**METROPOLITAN GOVERNMENT OF NASHVILLE AND DAVIDSON COUNTY**

**STAFF RECOMMENDATION**  
**1906 Sweetbriar Avenue**  
**December 17, 2014**

**Application:** New construction- addition  
**District:** Belmont-Hillsboro Neighborhood Conservation Zoning Overlay  
**Council District:** 18  
**Map and Parcel Number:** 10416024400  
**Applicant:** Bill Johnson, architect  
**Project Lead:** Sean Alexander, sean.alexander@nashville.gov

Recent photo, showing extent of proposed side addition.

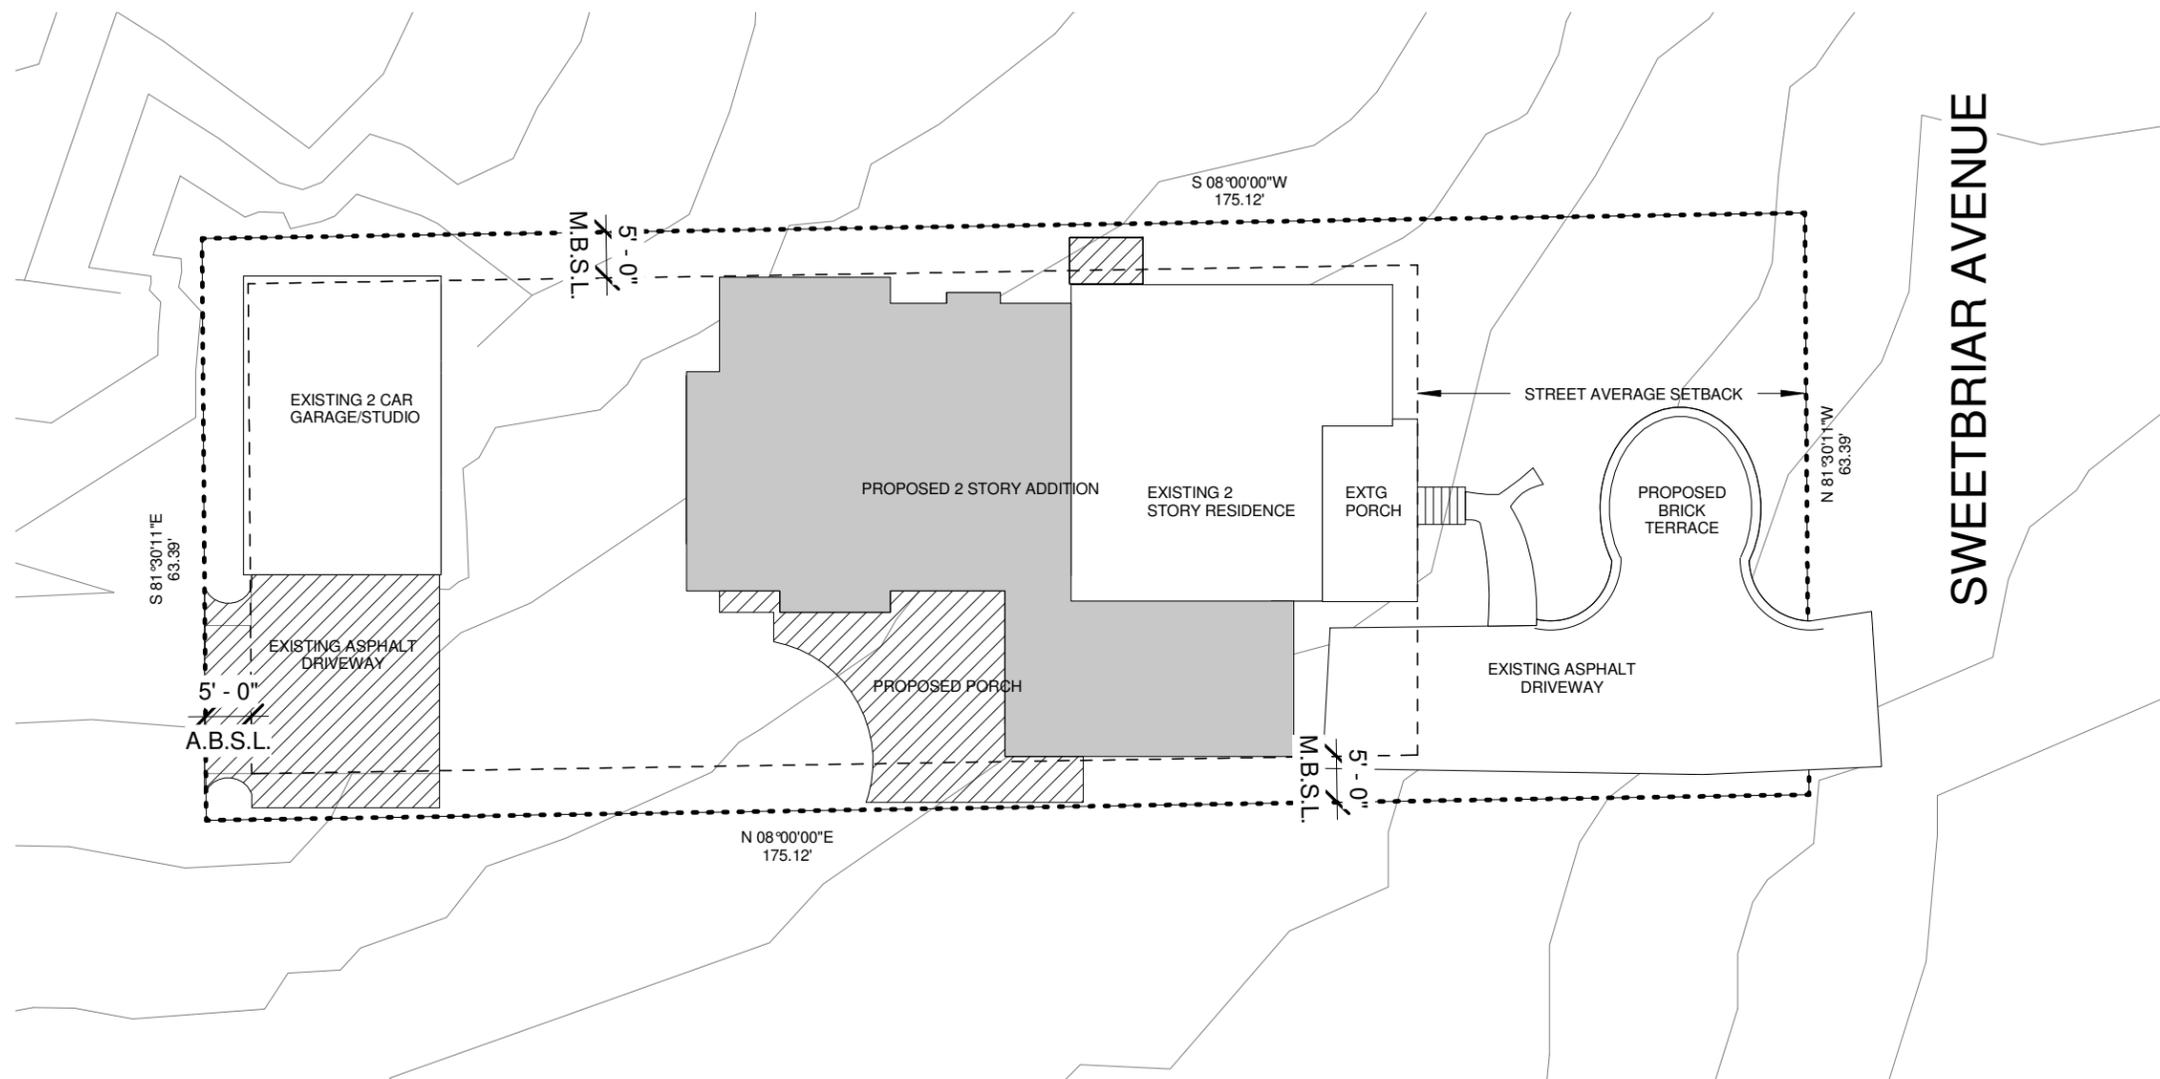
On the left side of the house, there is an existing gabled wing that was originally a street-facing garage that has been converted to living space. This wing is currently thirteen feet (13') wide, and will be expanded to be seventeen feet (17') wide. While side additions are generally not appropriate for historic houses, Staff finds this addition to be appropriate because the building is non-contributing.

**ARCHITECTURAL SITE PLAN**

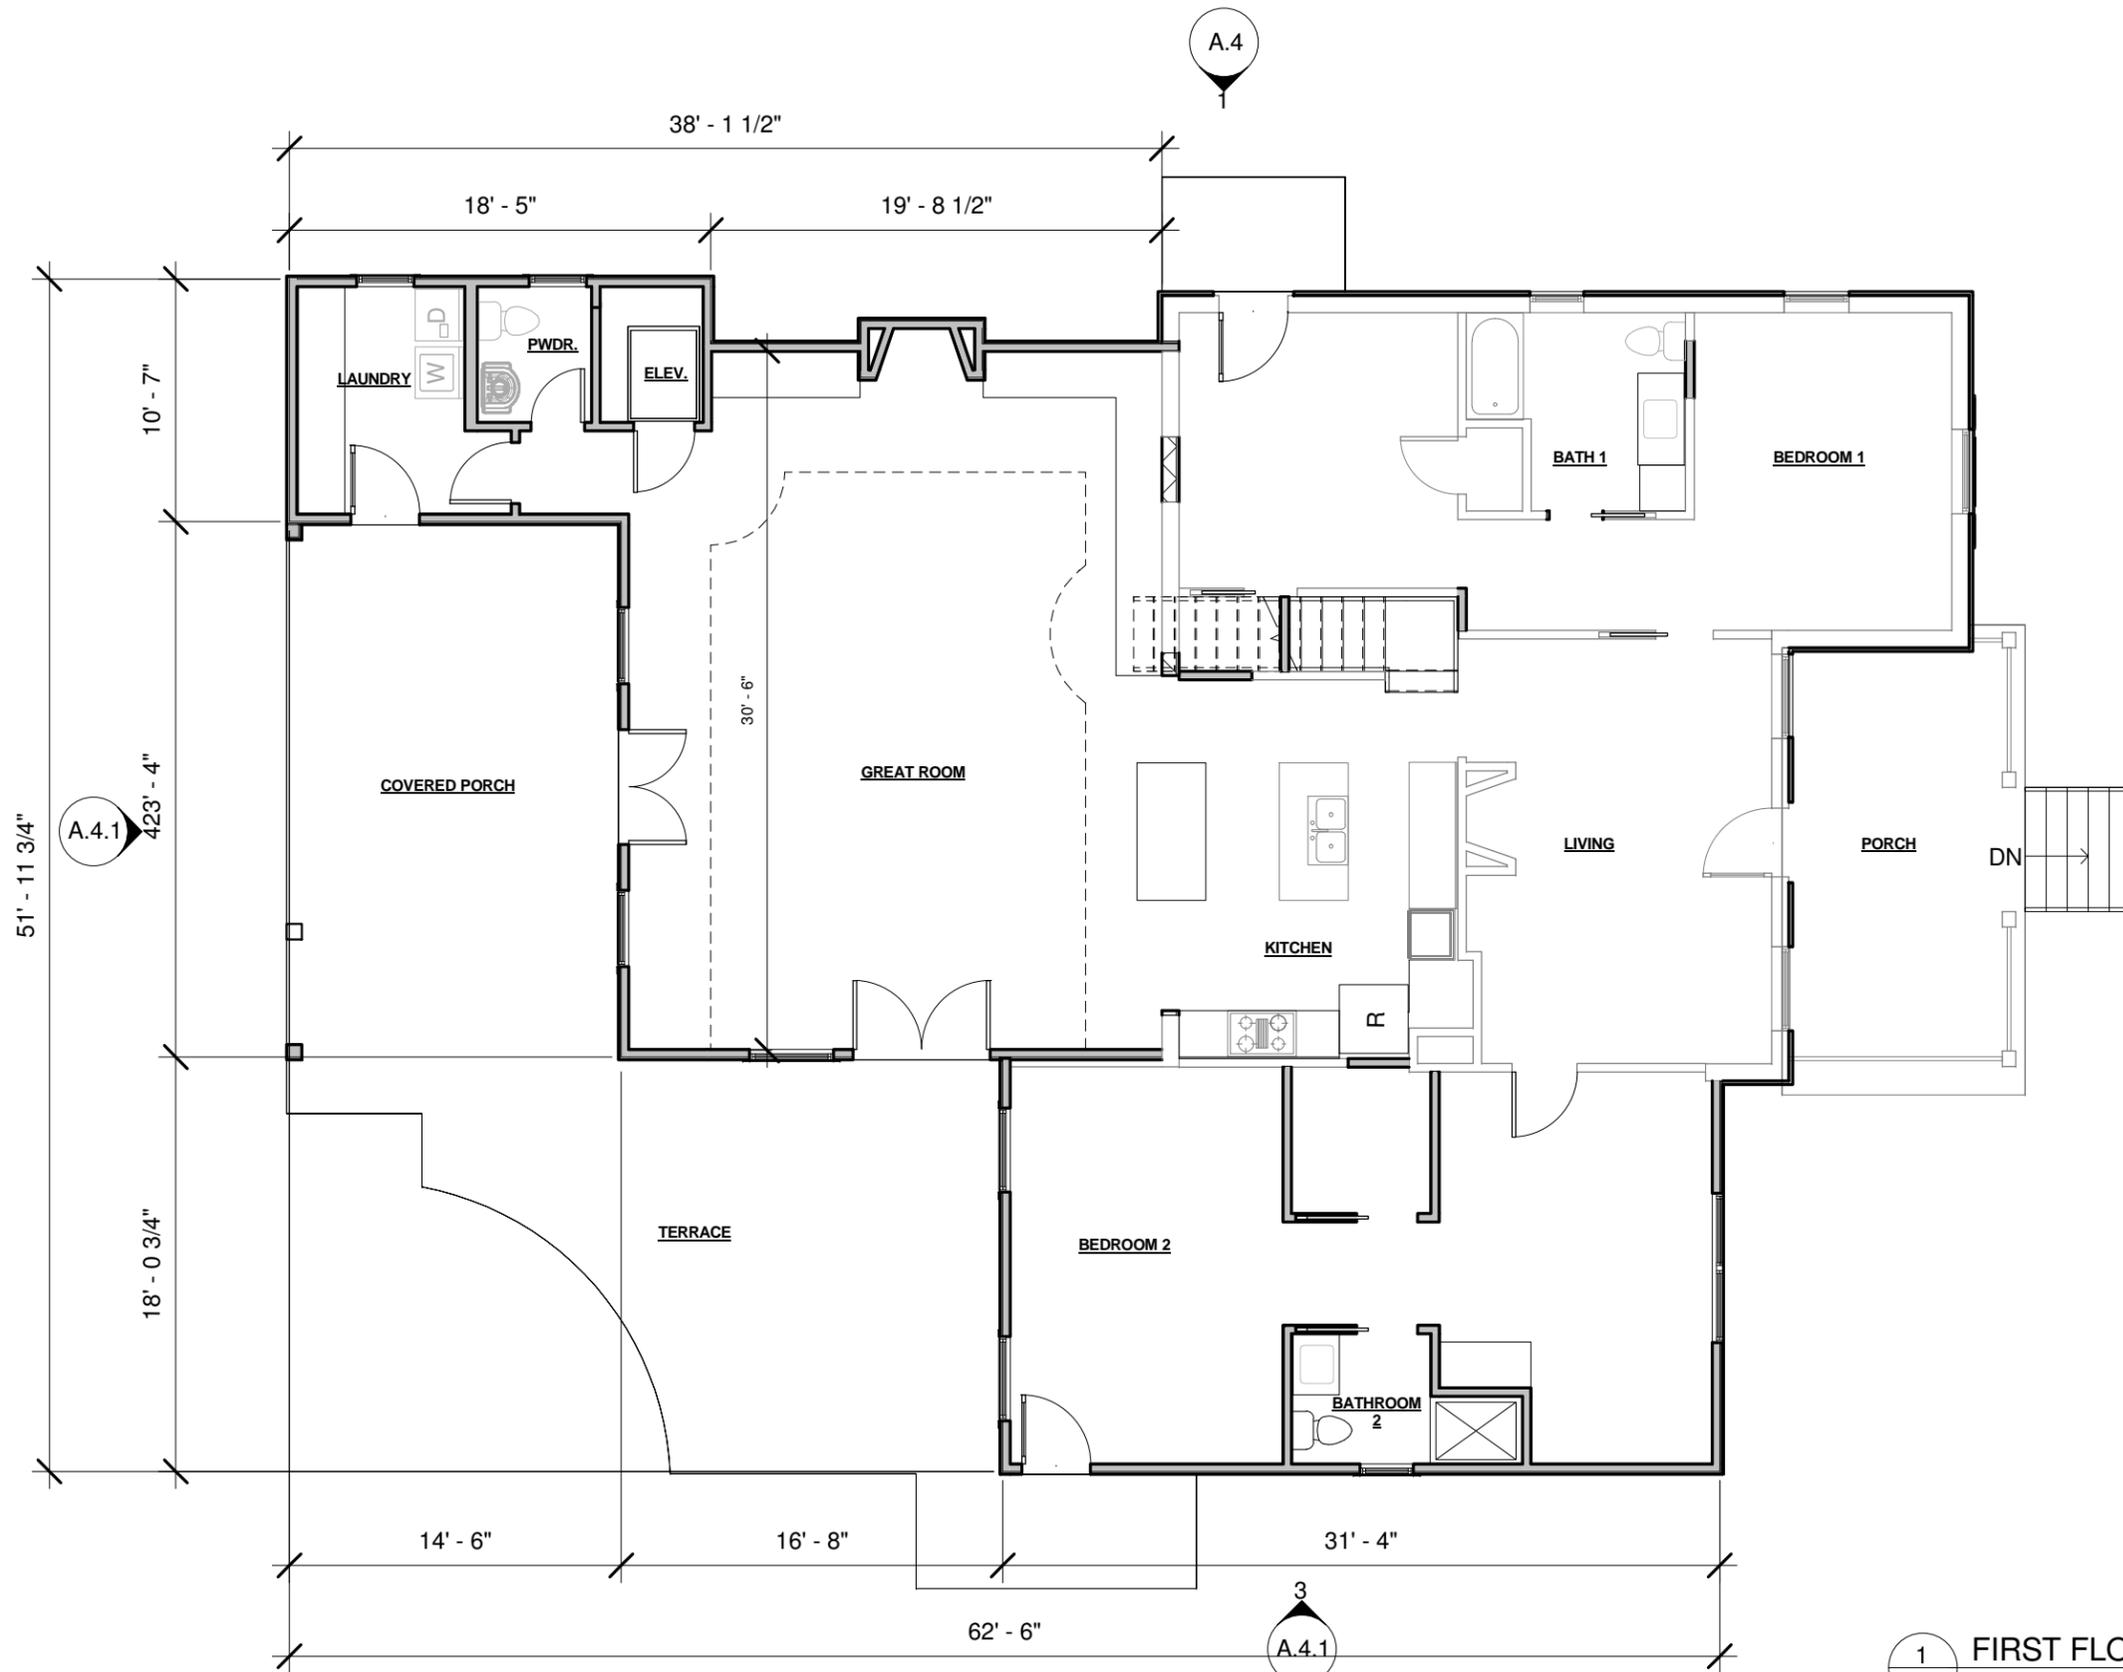
The additions will expand the structure to be fifty-two feet (52) wide, with the sides five feet (5') from the left and right side property lines. The lot is sixty-three feet (63') wide, but the existing structure is slightly off-axis which accounts for the one foot (1') difference. The additional width on the left side of the house begins fourteen feet (14') back from the front of the house, and fifty-six feet (56') back from the front of the property. The additional width on the right side begins fifty-eight feet (58') back from the front of the house and over one hundred feet (+100') from the front of the property. Because the additional width is minimal, four feet (4') on the left and nine inches (9") on the right, and because it is so far back from the street, it will not have a significant impact on the rhythm of spacing between houses on the street. The rear of the addition will be fifty-three feet (53') from the rear property line, and will be twenty-seven feet (27') from the existing outbuilding. These setbacks are appropriate and meet section II.B.1.c of the design guidelines.

**1 SECOND FLOOR PLAN**  
A.3.1 1/8" = 1'-0"

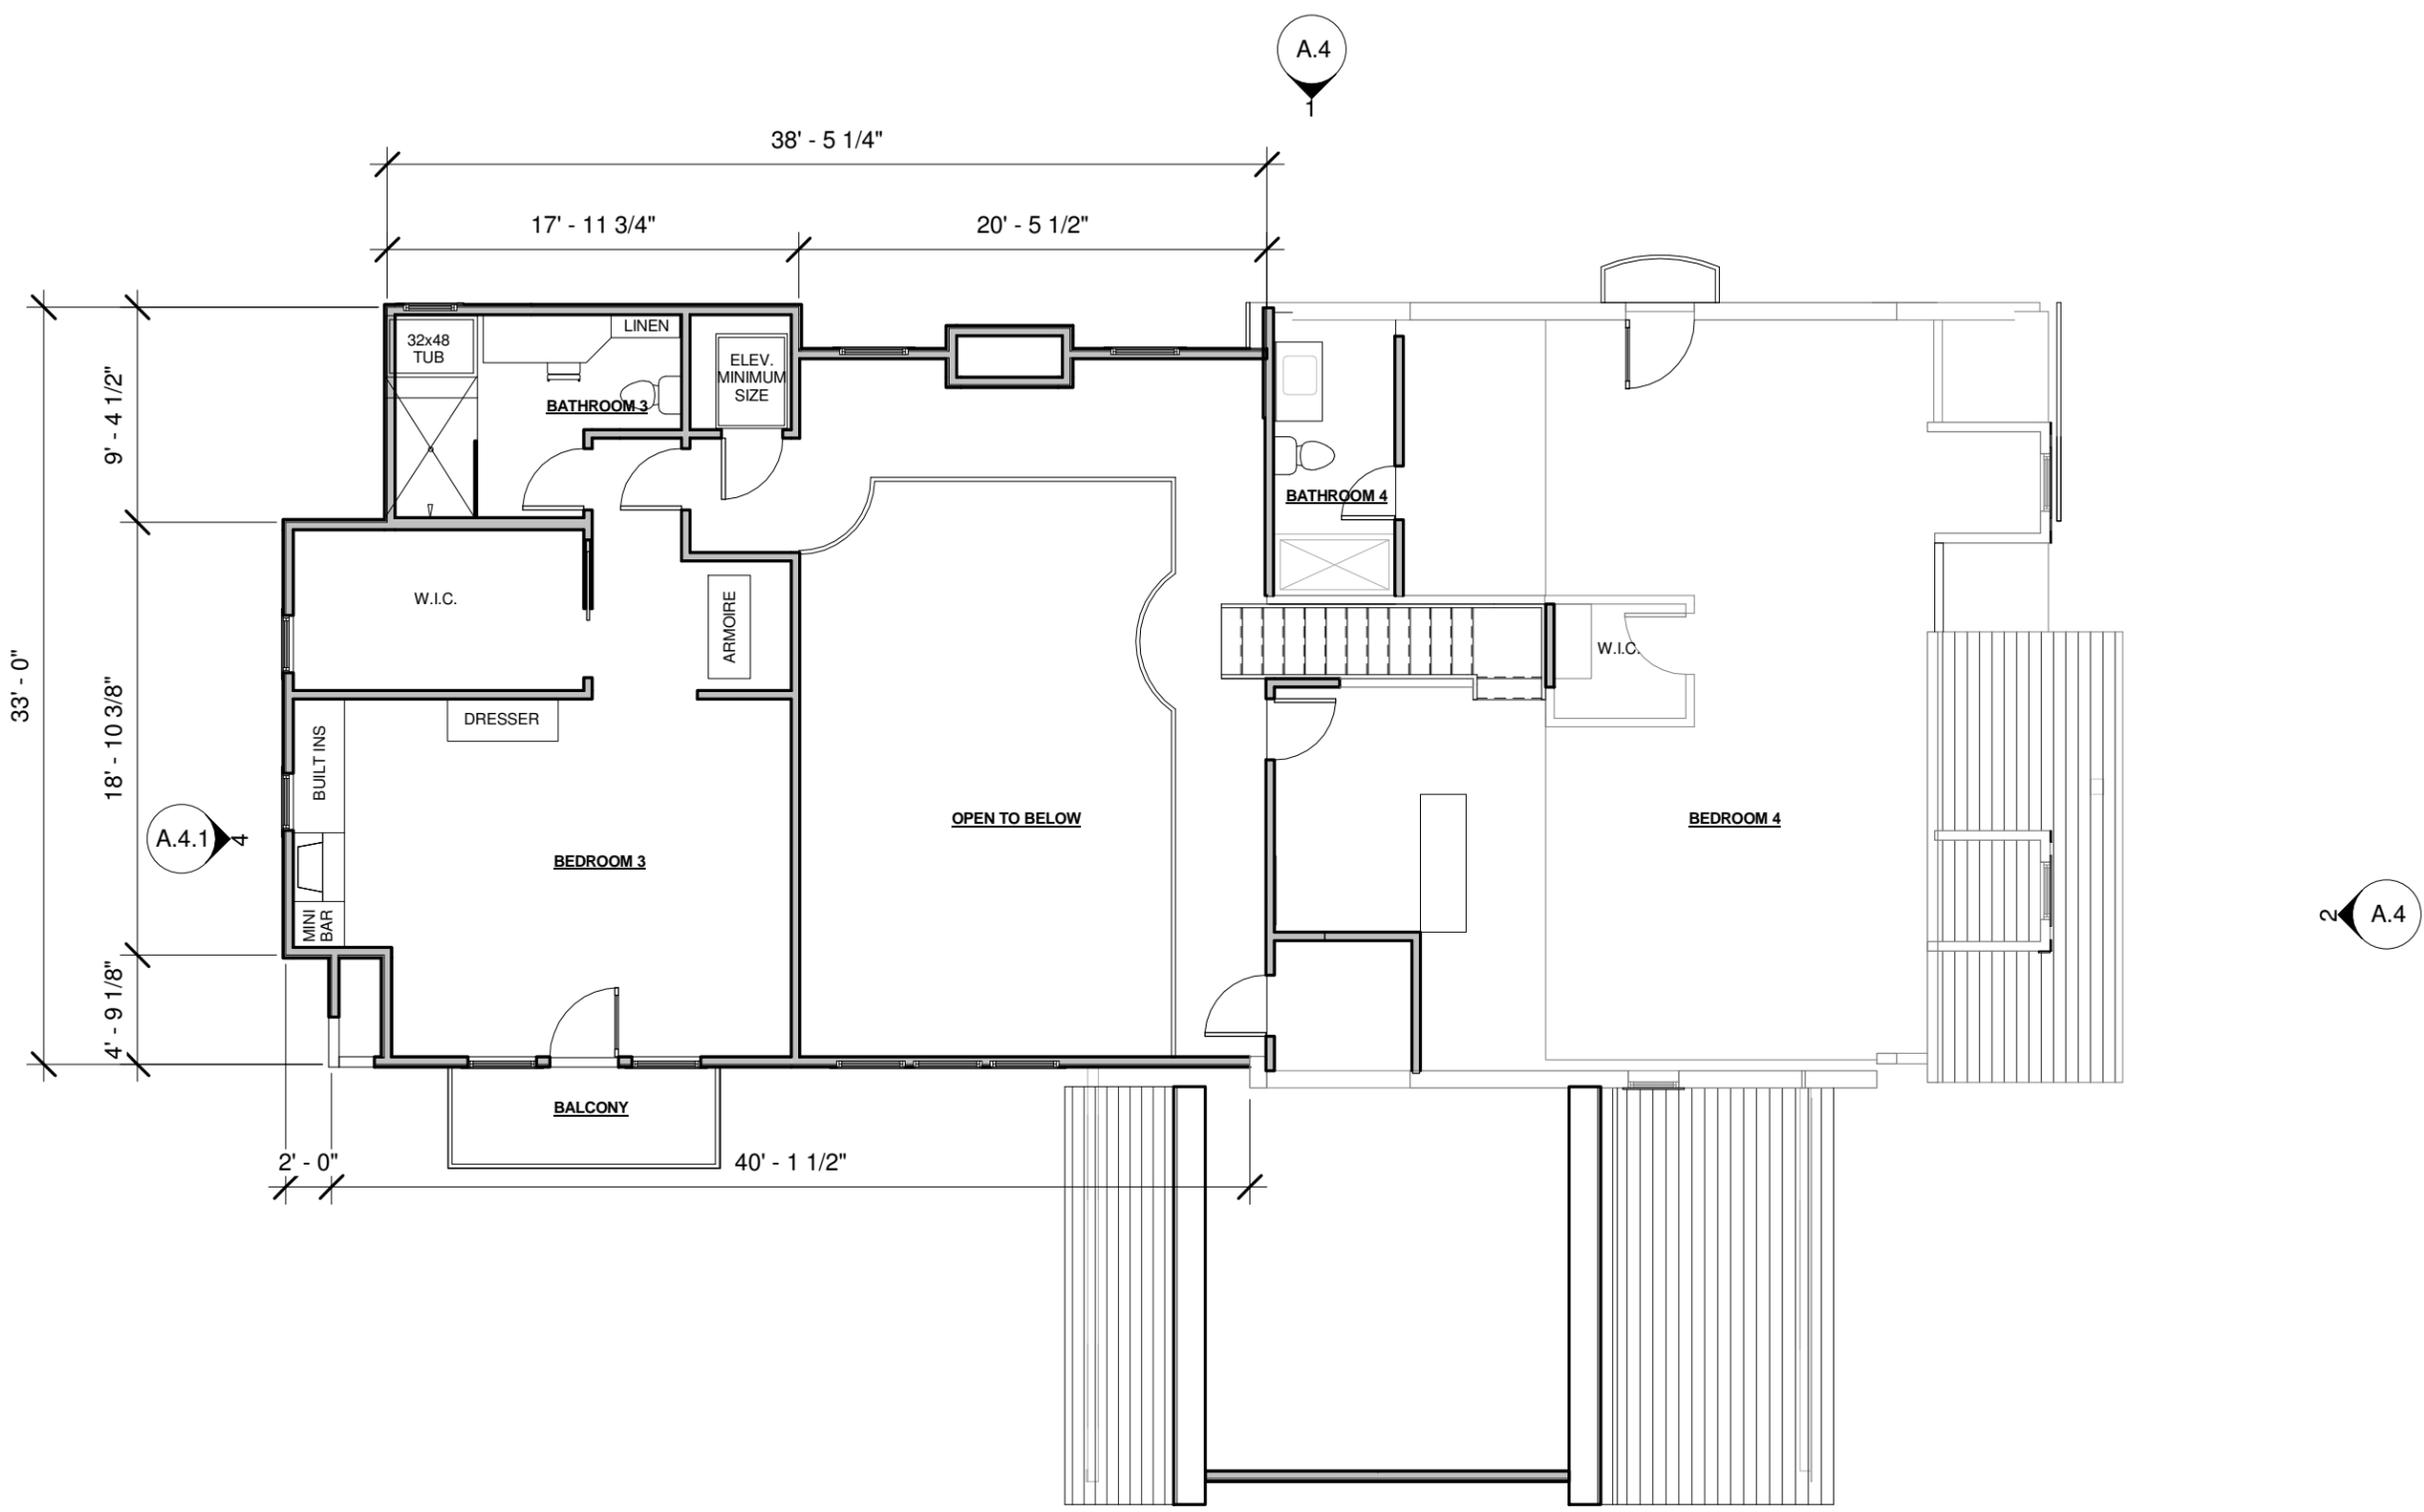
From the right-rear corner of the existing house, the addition will sit in two feet, two inches (2'-2") and extend twenty feet (20') back before stepping back out two feet, eleven inches (2'-11") to the right, which is nine inches (9") wider than the existing house. From there the addition continues back another eighteen feet (18'). While additions should generally not be wider than an historic house, staff finds the width of the proposed addition to be appropriate because the house is non-contributing. Although the addition will be two stories tall at the rear, the upperstory will sit in one foot (1') from the first story, keeping the two walls inside the silhouette of the existing house.

Behind the ridge raise and the primary roof, the addition will be two stories tall on the left side as it is on the right, sitting in one foot (1') from the side of the existing structure. Again, this addition is appropriate because it sits inside the silhouette of the historic house, and because the house is non-contributing. Staff finds that the project meets section II.B.1.a. and b.
